Process Sheet

Customer : CU-DAR001 Dart Helicopters Services	Drawing Name : DUCT	
Job Number : 32051		
Estimate Number : 12175		
P.O. Number : N/A	Part Number : D34761	
This Issue : 4/24/2007 S.O. No. : N/A	Drawing Number : D3476 REV A	
Prsht Rev. : NC	Project Number : N/A	
First Issue : N/A Type : SMALL /MED FAB	Drawing Revision : A	
Previous Run : 28873	Material : N/A	
Written By :	Due Date : 5/8/2007 Qty: 2 Um: Each	
Checked & Approved By : [Signature] 07.04.25

DESIGN <i>[Signature]</i>	DRAWN BY <i>[Signature]</i>	DART AEROSPACE LTD HAWKESBURY, ONTARIO, CANADA	
CHECKED <i>[Signature]</i>	APPROVED <i>[Signature]</i>	DRAWING NO. D3476	REV. A SHEET 1 OF 7
DATE 06.01.27		TITLE BLOWER MOTOR ADAPTER	SCALE 1:2
A	06.01.27	NEW ISSUE

**D3476-1 DUCT****DETAIL B**
SCALE 1 : 1**D3476-1F DUCT FLAT PATTERN****NOTES:**

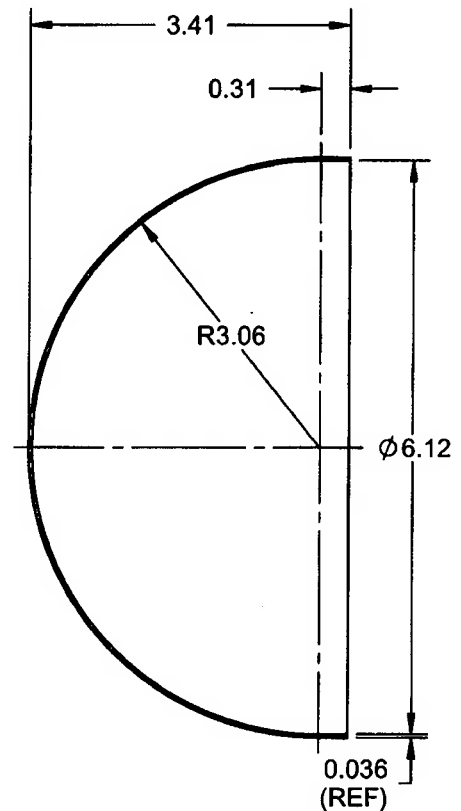
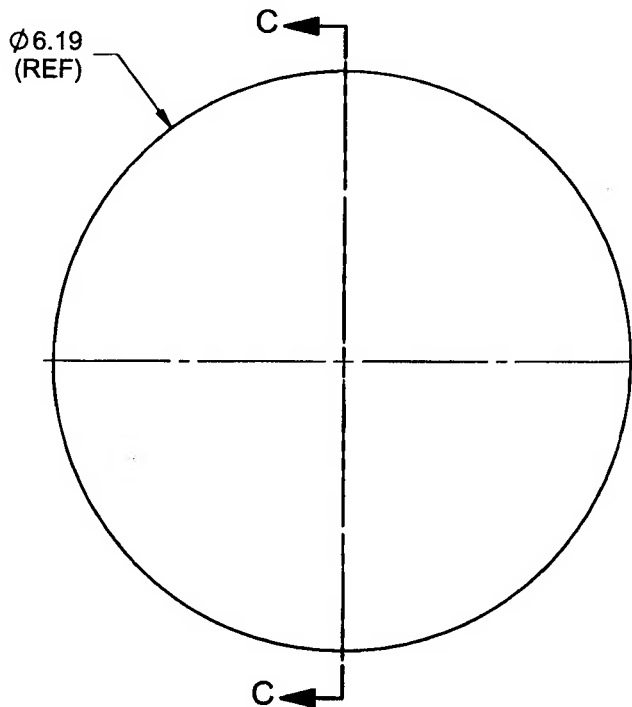
W/O:		WORK ORDER CHANGES						
DATE	STEP	PROCEDURE CHANGE	By	Date	Qty	Approval Chief Eng / Prod Mgr	Approval QC Inspector	
07-04-30	5	1 scrap because the diameter did fit the blower adapter but not the motor. The diameter of the motor was too big. Did not fit. Adjusted the other duct to fit both (blower + motor) Had to take .050 off of the seam to adjust to fit.	mf	07-04-30

NCR:		WORK ORDER NON-CONFORMANCE (NCR)						
DATE	STEP	Description of NC Section A	Corrective Action Section B			Verification Section C	Approval Chief Eng	Approval QC Inspector
			Initial Chief Eng	Action Description Chief Eng	Sign & Date			
07-04-30	5.	1 scrap because diameter fit blower adapter but not motor. The Ø of the motor was too big.		Took .050 off of seam and placed the duct to fit the outside of the blower instead of inside.	mf 07-04-30	 070501		 07-0501
